**ZONING AMENDMENT,
PLANNED UNIT DEVELOPMENT &
SUBDIVISION STAFF REPORT**

Date: June 5, 2014

<u>NAME</u>	Don Williams
<u>SUBDIVISION NAME</u>	La Belle Subdivision, Re-subdivision and Addition to Lot 1
<u>LOCATION</u>	5951 & 5955 Old Shell Road and 14 East Drive (Southwest corner of Old Shell Road and East Drive)
<u>CITY COUNCIL DISTRICT</u>	District 6
<u>CURRENT ZONING</u>	R-1, Single-Family Residential District, and B-2, Neighborhood Business District
<u>PROPOSED ZONING</u>	B-2, Neighborhood Business District
<u>REASON FOR REZONING</u>	Subdivision of land, and resolution of a split-zoning issue created by the proposed Subdivision.
<u>AREA OF PROPERTY</u>	1 Lots / 1.4± Acres
<u>CONTEMPLATED USE</u>	<p>Subdivision approval to create 1 legal lot of record, Planned Unit Development Approval to allow multiple buildings on a single building site and shared access between two building sites, and Rezoning from R-1, Single-Family Residential District, and B-2, Neighborhood Business District, to B-2, Neighborhood Business District to eliminate split zoning in a proposed Subdivision and allow construction of a parking lot.</p> <p>It should be noted, however, that any use permitted in the p

SITE PLAN

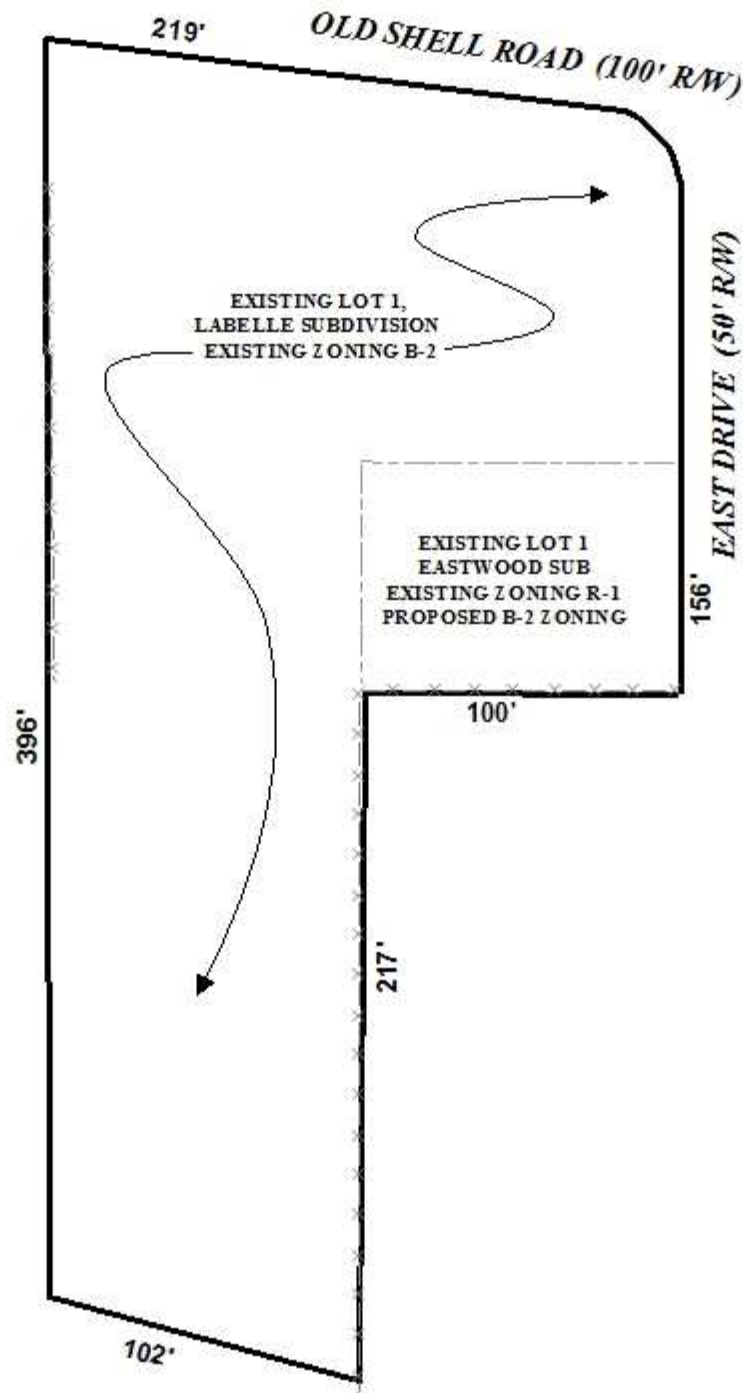
As a new curb-cut is proposed onto East Drive, staff recommends that the existing one-lane wide driveway on the West side of site be eliminated. The paving should be removed along the entire length abutting the Picklefish restaurant, the area landscaped, and curbing added to prevent access from Old Shell Road or from the existing parking lot.

Access to the new parking area from the existing parking area will be via a 24-foot wide driveway that will extend between two existing parking spaces. As no curbing or radius is provided for the driveway, cars parked in the existing parking spaces will likely be at high risk for damage by other vehicles, including delivery trucks, which will inevitably choose to enter or exit via the East Drive curb-cut. Staff recommends that the two abutting parking spaces be eliminated and replaced with curbed planting islands.

A sidewalk along East Drive is not depicted where the new parking area is proposed. As the site is commercial, a sidewalk waiver request must be submitted to the Planning Commission for consideration, or a sidewalk must be provided.

The existing dumpsters do not meet the 10-foot setback requirement for commercial sites abutting residentially zoned properties. While an appropriate dumpster enclosure is proposed, there appears to be sufficient room to relocate the dumpsters and the proposed enclosure to meet all setback requirements. Relocation of dumpsters will require sanitary sewer connections.

Finally, there was an unpermitted addition to the Picklefish building after the initial PUD approval in 2011, and it is not reflected on the submitted site plan.
